HISTORIC AND DESIGN REVIEW COMMISSION

HDRC CASE NO: 2022-413
ADDRESS: 326 RIVERSIDE DR
LEGAL DESCRIPTION: NCB 7672 BLK 21 LOT NW 170 X 15 OF 5, N IRR 190 OF 6, N 207.86 OF 7, N 207.86 OF E 102 OF 8
ZONING: IDZ-1, H, RIO-5
CITY COUNCIL DIST.: 3
DISTRICT: Mission Historic District
APPLICANT: NICHOLAS MELDE
OWNER: 326 RIVERSIDE LLC
TYPE OF WORK: Construction of a 2-story residential structure
APPLICATION RECEIVED: August 02, 2022
60-DAY REVIEW: Not applicable due to City Council Emergency Orders
CASE MANAGER: Edward Hall

The applicant is requesting a Certificate of Appropriateness for approval to construct a 2-story, residential structure at 326 Riverside Drive, located within the Mission Historic District.

1ST FLOOR PLAN
SCALE: 3/8" = 1'-0"

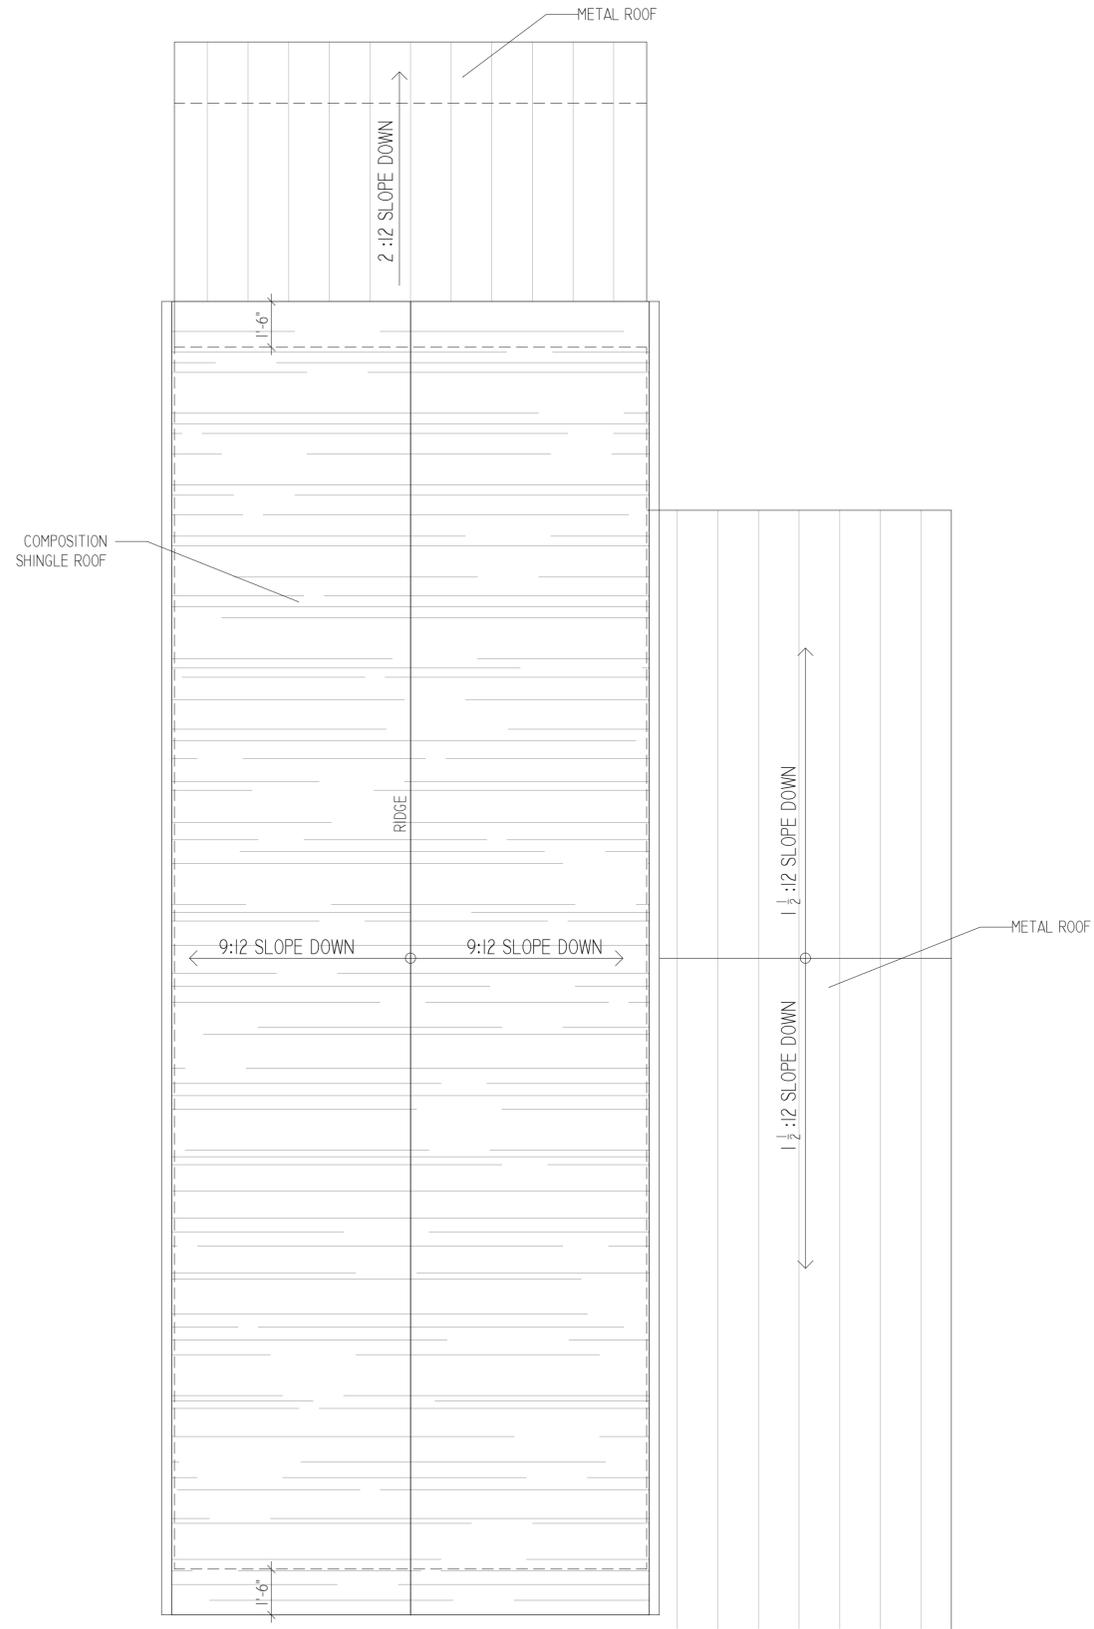
- m. CARPORT – The applicant has proposed for the new construction to feature an attached carport. Attached vehicular parking (including carports) is not found historically within historic districts. The Guidelines note that parking should be located at the rear or detached from a historic structure. The applicant has proposed to set back the carport from the front façade of the new construction by 5’ – 4”. Per the submitted site plan, parking will be accessed from the rear of the proposed new construction. Generally, staff finds that the most appropriate approach to parking would be for a detached carport.

LOT LINE ELEVATION - TYPE A2
 SCALE: 1/4" = 1'-0"

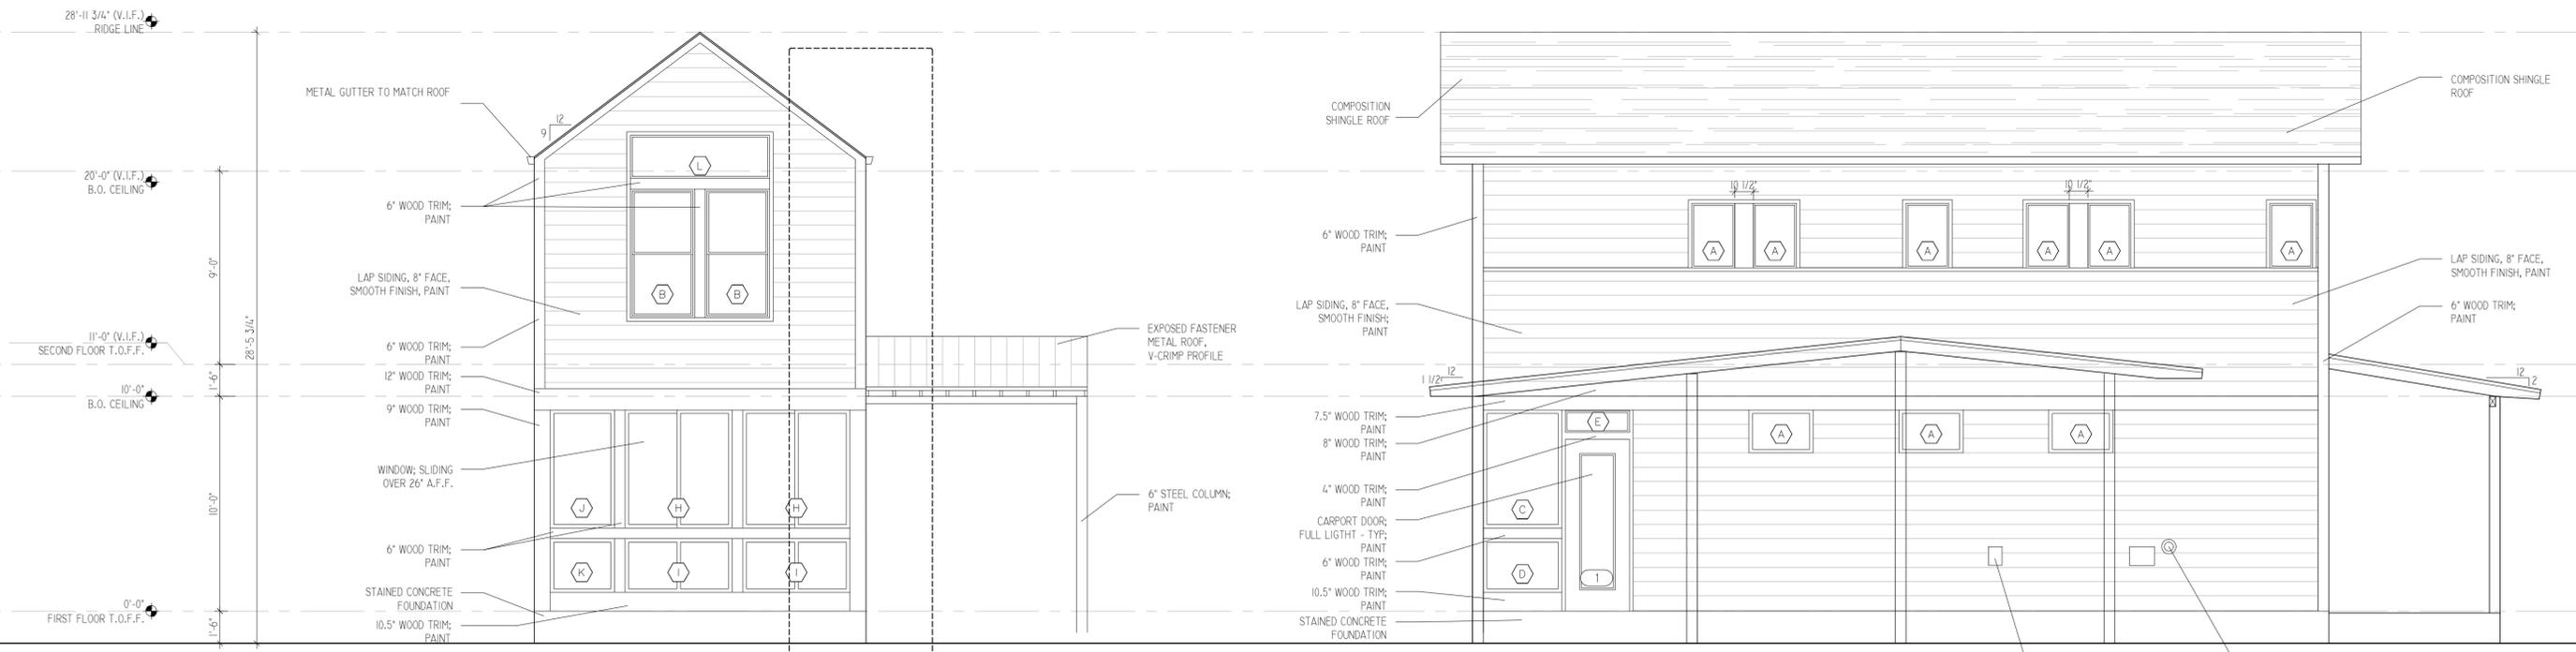
- l. ARCHITECTURAL DETAILS – As noted in finding h, staff finds that additional fenestration should be added to the west façade, and that all windows should feature a one over one profile. Windows that are grouped should be separated by a mullion of approximately six (6) inches in width. Additionally, staff finds that a standing seam metal roof should be used in place of a v crimp roof, as noted in finding j.

- iii. That additional fenestration should be added to the west elevation, which currently features only two window openings.
- iv. That the proposed porch columns feature capital and base trim and be six (6) inches square.
